**Staff Analysis of Proposed Amendment to the
Dane County Water Quality Plan,
Revising the Cross Plains Sewer Service Area Boundary and
Environmental Corridors in the Town of Berry and Village of Cross Plains**

Map 8 – Potential Seasonal High Groundwater and Shallow Bedrock

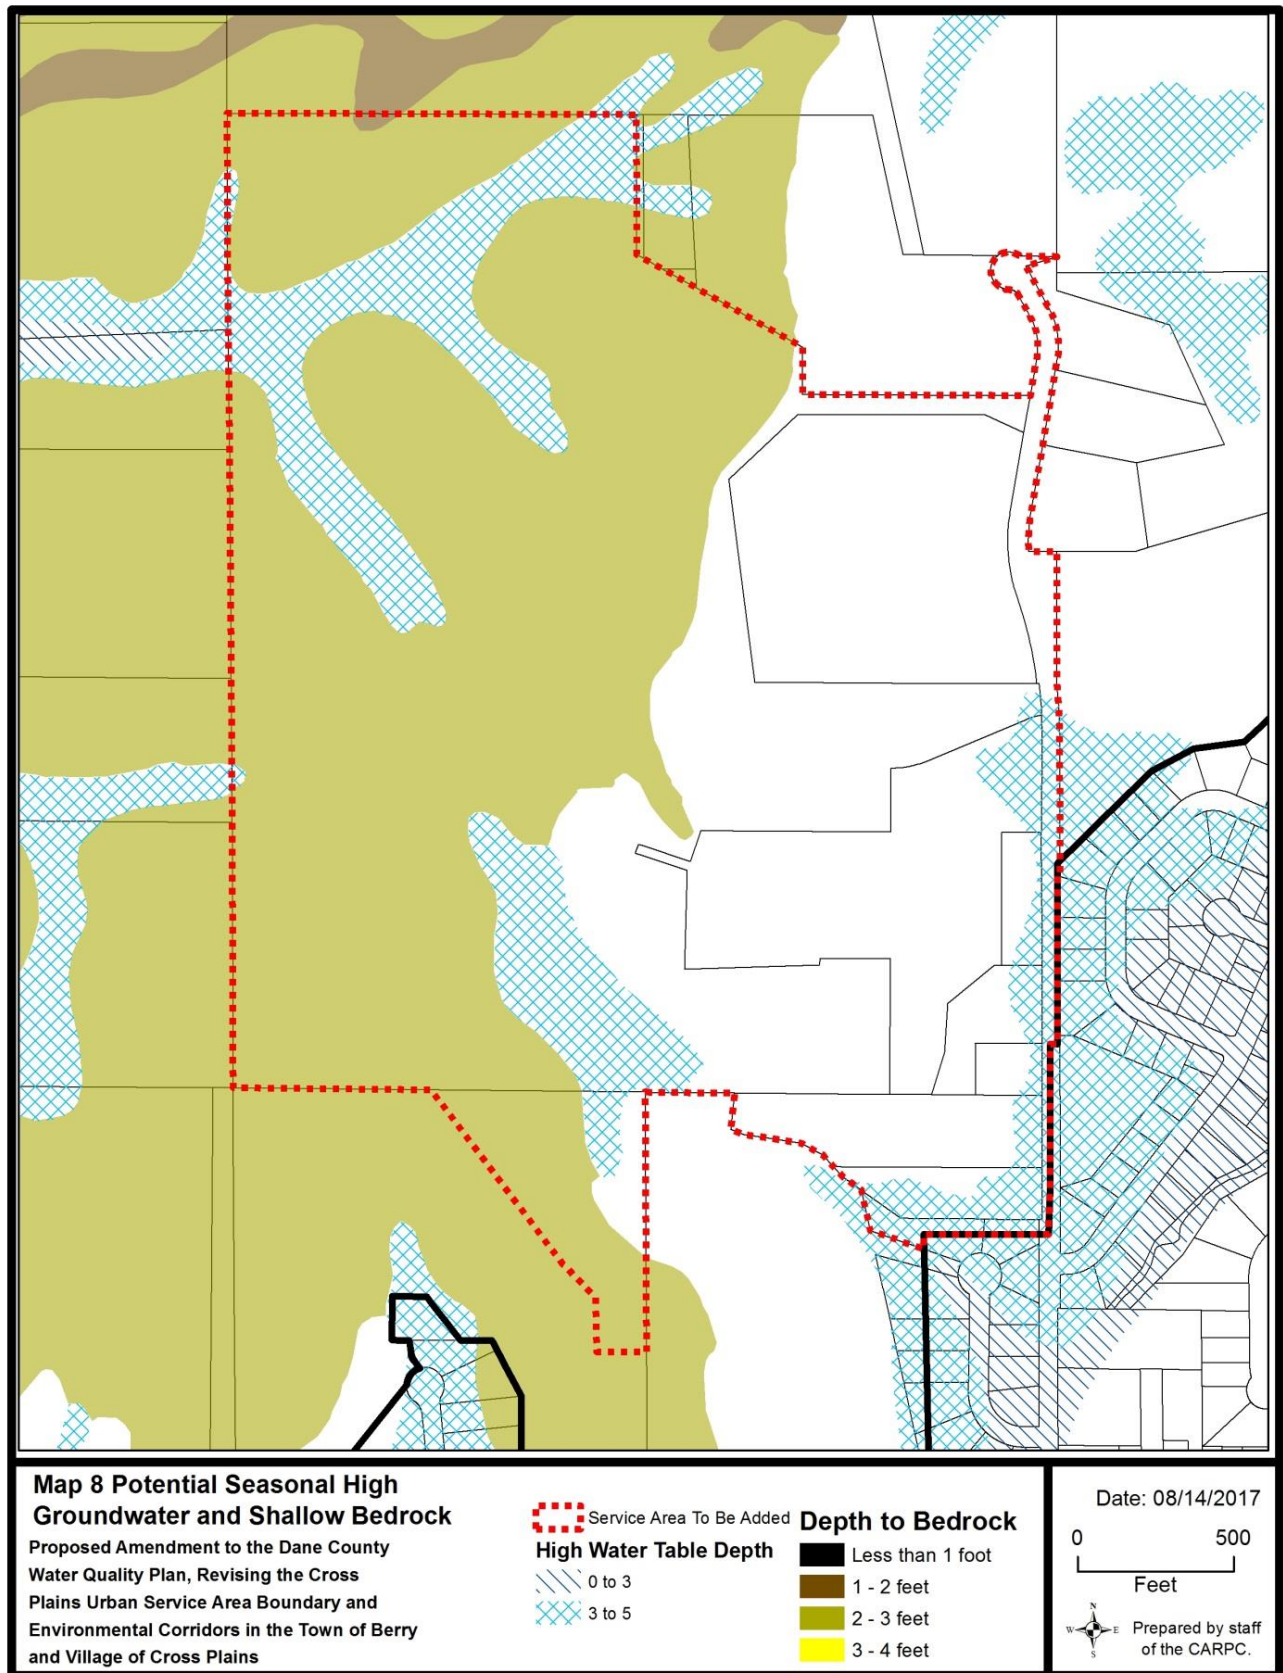
According to Wisconsin Geological and Natural History Survey mapping, the majority of bedrock within the amendment area is in the Prairie du Chien Group, which is dolomite, minor sandstone, cherty dolomite; vuggy, sandy, and oolitic, consisting of two formations, the Shakopee and the Oneota. It varies in thickness from 145 feet in eastern Dane County to 220 feet in western Dane County. The bedrock under the southeast and northwest corners of the amendment area is in the Trempealeau Group, which is quartz sandstone, dolomitic siltstone, silty dolomite, and sandy dolomite, consisting of two formations, the Jordan and the underlying St. Lawrence Formations, which were combined as one mapping unit. The bedrock thickness is about 75 feet, where not eroded. The depth to bedrock generally ranges from 5 to 50 feet in the eastern half of the amendment area. The depth to bedrock in the western half of the amendment area is 2 to 3 feet, based on NRCS Soil Survey data (See Map 8).

According to the USDA soil classifications for the amendment area, the soils underlying the proposed western stormwater management facilities typically exhibit shallow bedrock within 2-3 feet of the surface and the southern and eastern stormwater management facilities typically exhibit shallow groundwater within 5 feet of the surface, both of which are limitations to infiltration of non-roof runoff. The Wisconsin Department of Natural Resources Conservation Practice Standard 1002 - Site Evaluation for Stormwater Infiltration requires field verification for areas of the development site considered suitable for infiltration. This includes a site assessment for karst features on the site to locate infiltration facilities appropriately so that performance can be maximized while protecting groundwater resources. Additionally, as a large percentage of the site soils are characterized by shallow bedrock and groundwater (48% of site by bedrock and 15% by groundwater), it is recommended that the Village consider distributed infiltration facilities, such as terrace bioretention, residential rain gardens and porous pavement, upstream of the proposed stormwater management facilities locations should limiting conditions be found at the current conceptual locations.

2. Conduct a field verification for areas of the development site considered suitable for infiltration including a site assessment for karst features as required by the Wisconsin Department of Natural Resources Conservation Practice Standard 1002 - Site Evaluation for Stormwater Infiltration.

Map 9 – Planned Sanitary Sewer Service

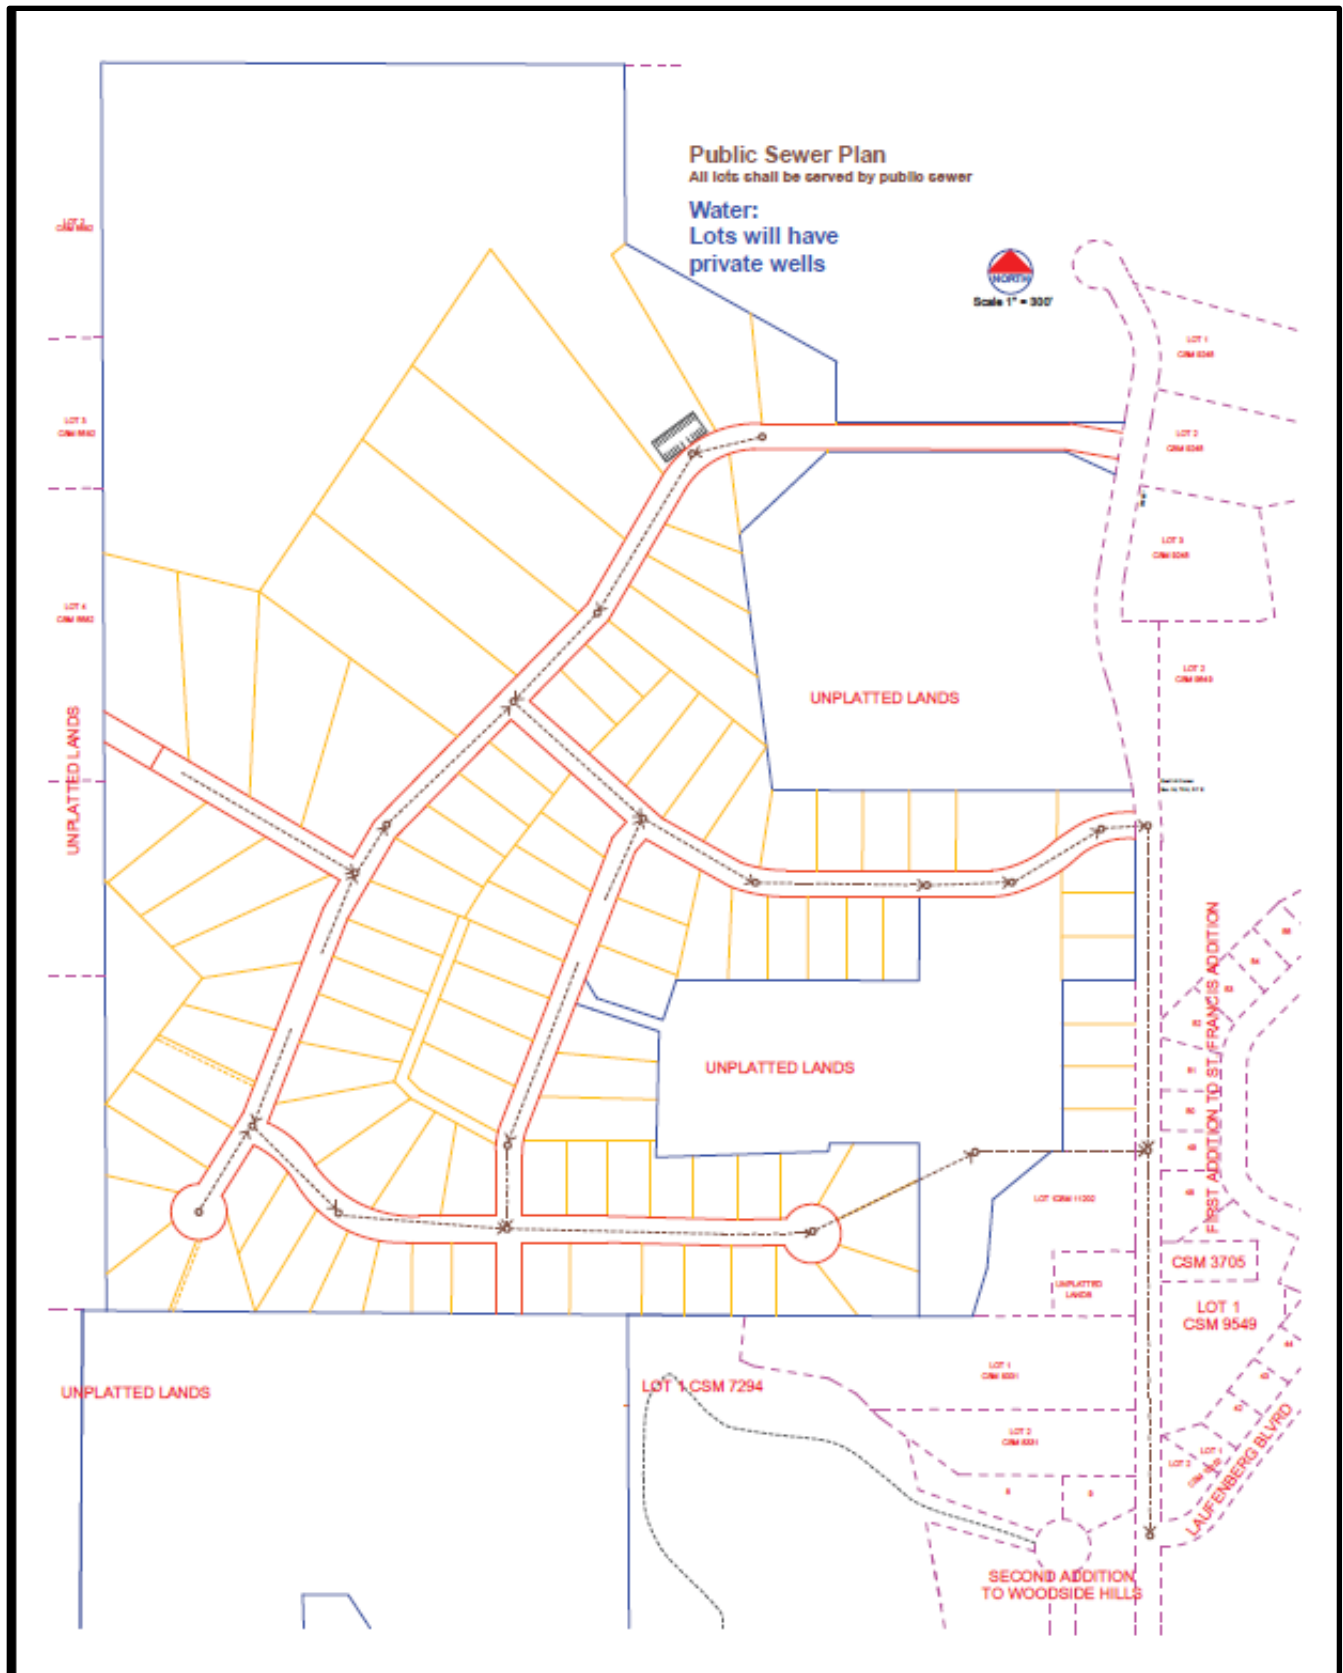
Sanitary sewer service will be provided to the amendment area through an 1,850 foot extension along Brewery Road, connecting to the existing municipal sanitary sewer system at a manhole near the intersection of Brewery Road and Laufenberg Boulevard at the southeast corner of the amendment area (see Map 9). Due to topography, the Village anticipates that a grinder pump will be required to service the proposed residential lots along the west-central edge of the amendment area.

The Village estimates that the amendment area will generate an average of 23,300 gpd (16 gpm), assuming 2.5 persons per home and 65 gpd per person. Using a peaking factor of 4, it is estimated that the amendment area would generate a peak flow of 65 gpm. The estimate is consistent with historical wastewater generation rates in the Village. The Village has determined that the Brewery Road interceptor has an existing capacity of 0.60 cubic feet per second (cfs). Including the proposed development, at full buildout the peak flow would increase to 0.64 cfs. The Brewery Road interceptor is due for replacement. The Village will replace the Brewery Road interceptor with additional capacity prior to full buildout of the amendment area. The downstream interceptors all have sufficient capacity to accommodate the anticipated increase in flow resulting from the amendment area.

There is sufficient existing or planned (Brewery Road Interceptor replacement) wastewater collection system capacity to serve the proposed amendment area. There is sufficient existing treatment plant system capacity to serve the proposed amendment area.

Map 10 – Proposed Stormwater Management System

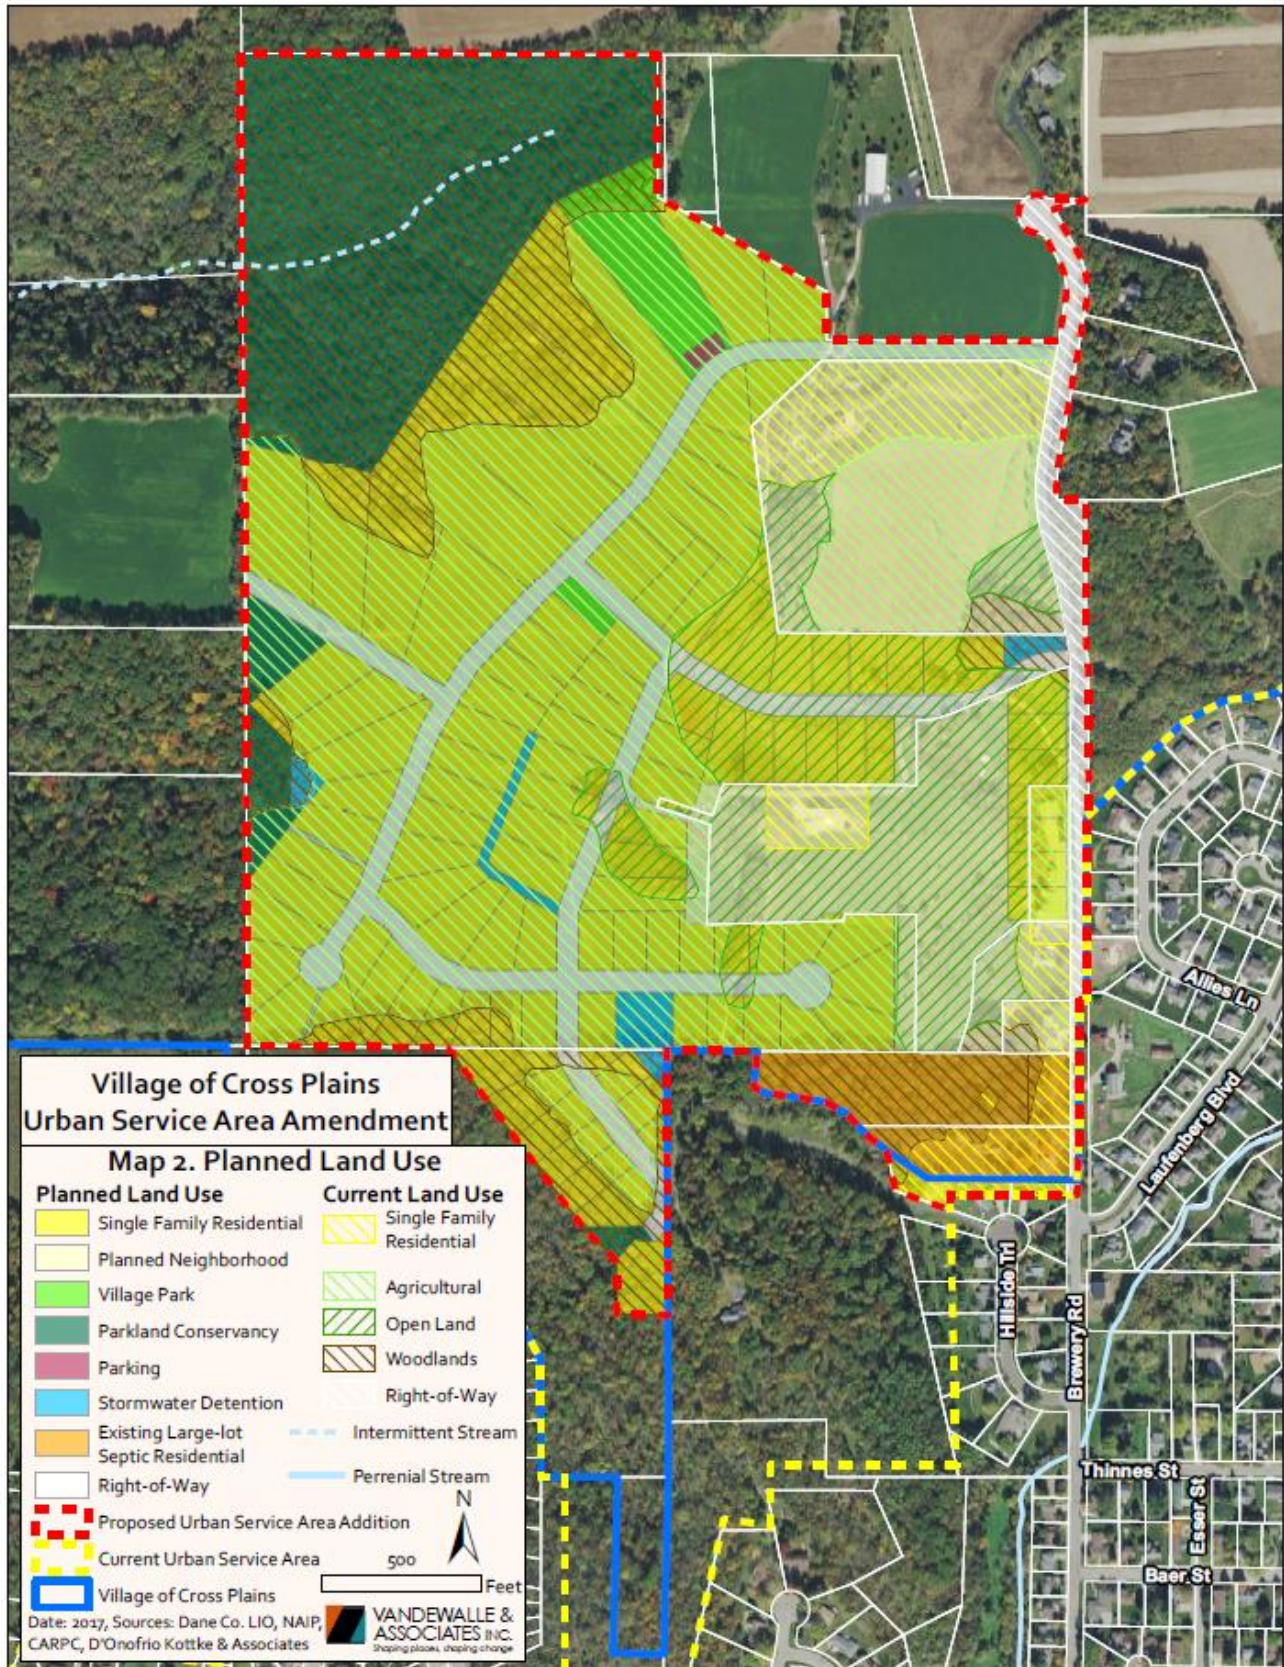
The preliminary stormwater management plan for the amendment area includes a hybrid swale-based road profile and a network of four stormwater management facilities. The swale-based road profile replaces a traditional curb-and-gutter section in a large portion of the development area and provides water quality and quantity treatment where a traditional inlet and piped conveyance system does not. These facilities will generally be strategically located to adequately provide water quality treatment (80% TSS reduction) followed by volume reduction facilities, which will provide for annual stay-on (100% stay-on). It is anticipated that infiltration performance will further reduce TSS (and other pollutants such as Total Phosphorus) from stormwater discharges as well as reduce the temperature. Collectively, the stormwater facilities will provide peak discharge rate control to account for storms up to and including the 100-year rainfall event. The stormwater facilities will be owned and maintained by the Village of Cross Plains.

1. Submit a detailed stormwater management plan for Regional Planning Commission staff review and approval (in conjunction with DCL&WCD staff) prior to any land disturbing activities in the amendment area. The stormwater management plan shall include the following:

3. Stormwater management facilities shall be placed in public outlots whenever feasible and designated as environmental corridor. Easements and perpetual legal maintenance agreements with the Village, to allow the Village to maintain stormwater management facilities if owners fail to do so, shall be provided for any facilities located on private property.

1. Consider distributed infiltration facilities, such as terrace bioretention, residential rain gardens and porous pavement, upstream of the proposed stormwater management facilities locations should limiting conditions be found at the proposed infiltration locations.
2. Encourage the responsible use of deicers as part of the [WI Salt Wise Partnership](#).
3. Work with Regional Planning Commission staff to develop a long term water supply plan for the Village using the regional groundwater model.
4. Conduct joint comprehensive planning with the Town of Berry and the Town of Cross Plains.

Map 11 – Municipal Wells and Modeled Baseflow Locations

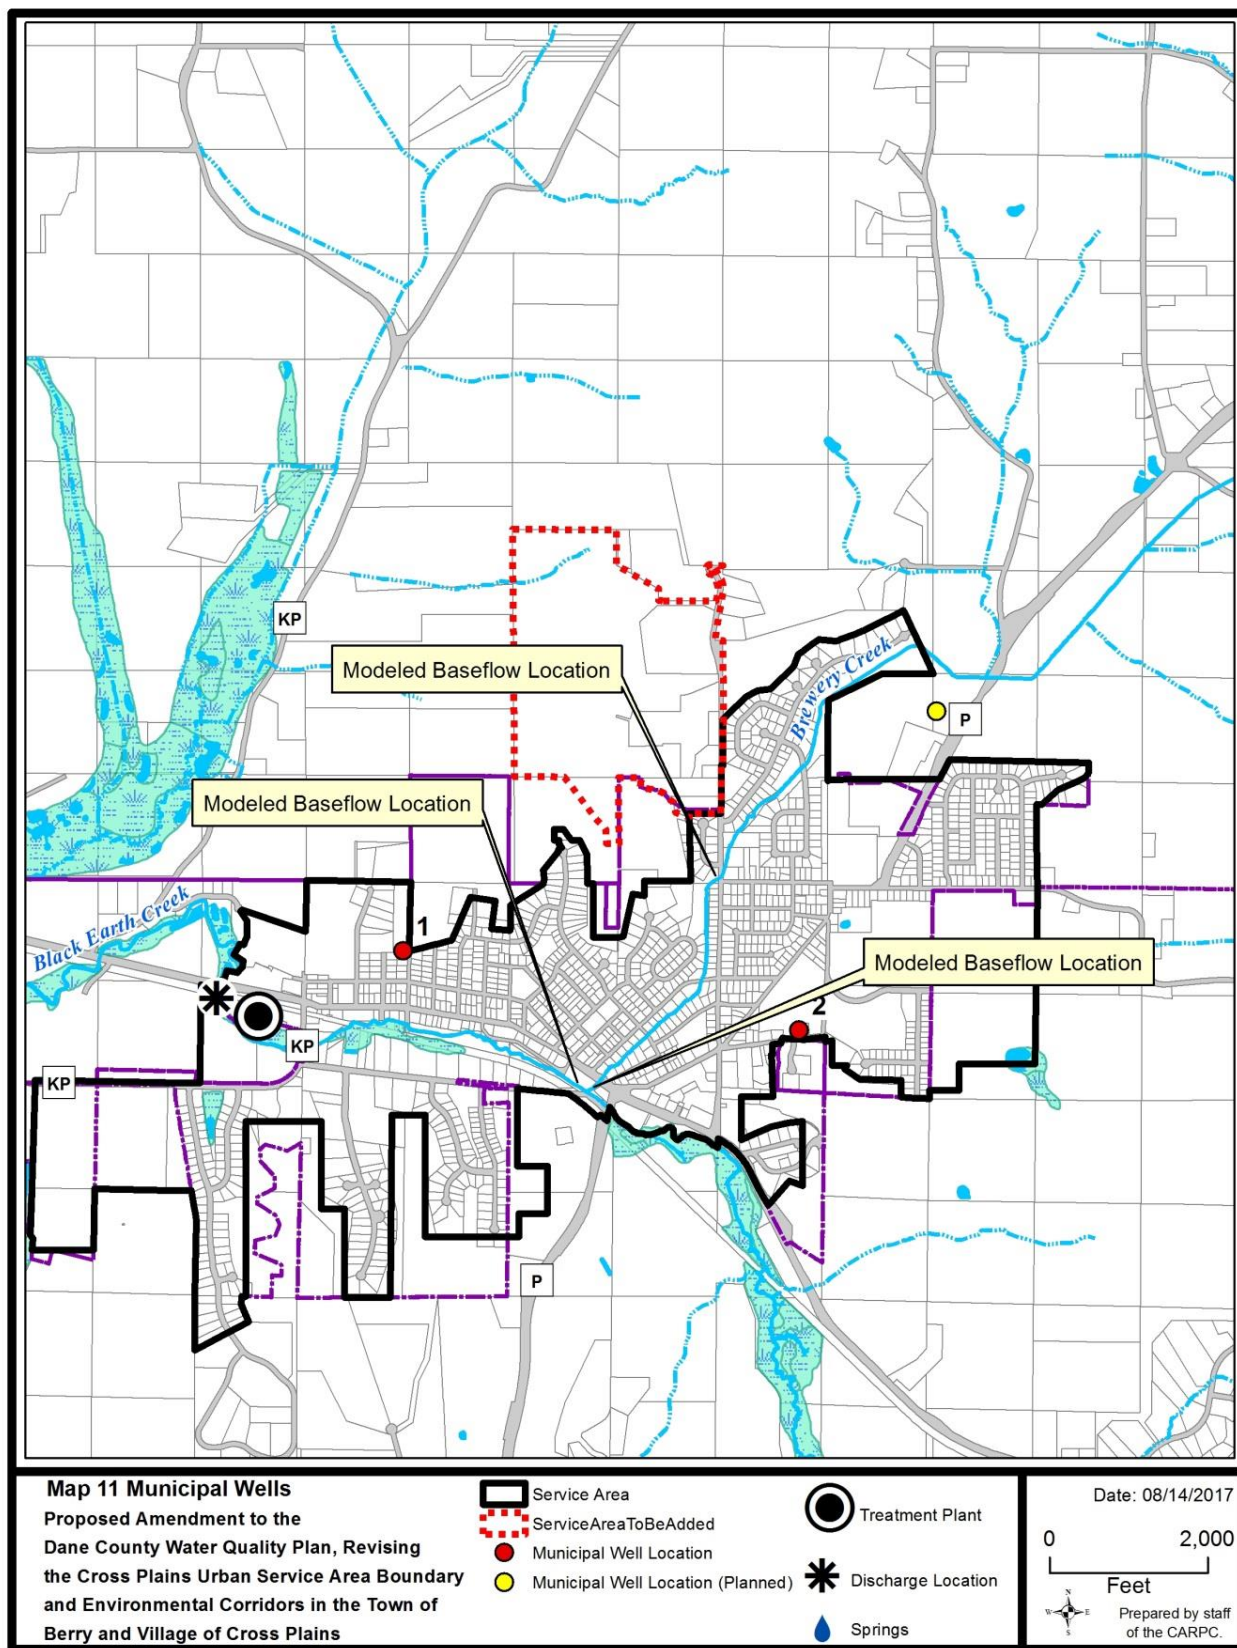
Groundwater modeling indicates that the cumulative effects of year 2010 well water withdrawals from all municipalities have resulted in a 0.26 cfs decline in baseflow in Upper Brewery Creek immediately below the amendment area (see Map 11 and Table 4) compared to the pre-development (no pumping) baseflow of 2.07 cfs. An additional 0.18 cfs decline is anticipated by the year 2040, according to modeling, reducing the baseflow to 1.63 cfs. Similar reductions are shown for Lower Brewery Creek and in Black Earth Creek immediately downstream. According to the 2014 DNR report [*Ecological Limits of Hydrologic Alteration in Dane County Streams*](#), significant change in the fish community status from 2010 conditions is not expected to occur as a result of the projected 2040 reduction in baseflow in Brewery Creek or Black Earth Creek. There is a very slight decrease in baseflow in Upper Brewery Creek (0.01 cfs) resulting from Sundance residents being served by shallow private wells, versus much deeper municipal wells drawing from regional sources.

The loss of baseflow from the cumulative effects of well water pumping is a regional issue, beyond the boundaries of a single Urban Service Area Amendment or even a single municipality. This is illustrated by the comparatively lower baseflow reductions due to just Village of Cross Plains municipal well water withdrawals shown in Table 5. This issue is discussed along with potential management options in the recently updated [*Dane County Groundwater Protection Planning Framework*](#) (Technical Appendix G of the Water Quality Plan).

Maintaining pre-development groundwater recharge also helps to maintain baseflow and mitigate this impact. The Village of Cross Plains proposes to maintain the pre-development annual recharge rate (estimated as 9 to 14 inches per year for this area according to the Wisconsin Geological and Natural History Survey study). Experience has shown that this criterion is generally met when 90% of pre-development runoff volume is maintained for the development area through infiltration measures, the Village goes beyond this by requiring 100% of pre-development runoff volume conditions be maintained. In addition, the riparian woodland, which generally function as groundwater recharge areas, have been preserved and placed in environmental corridors.
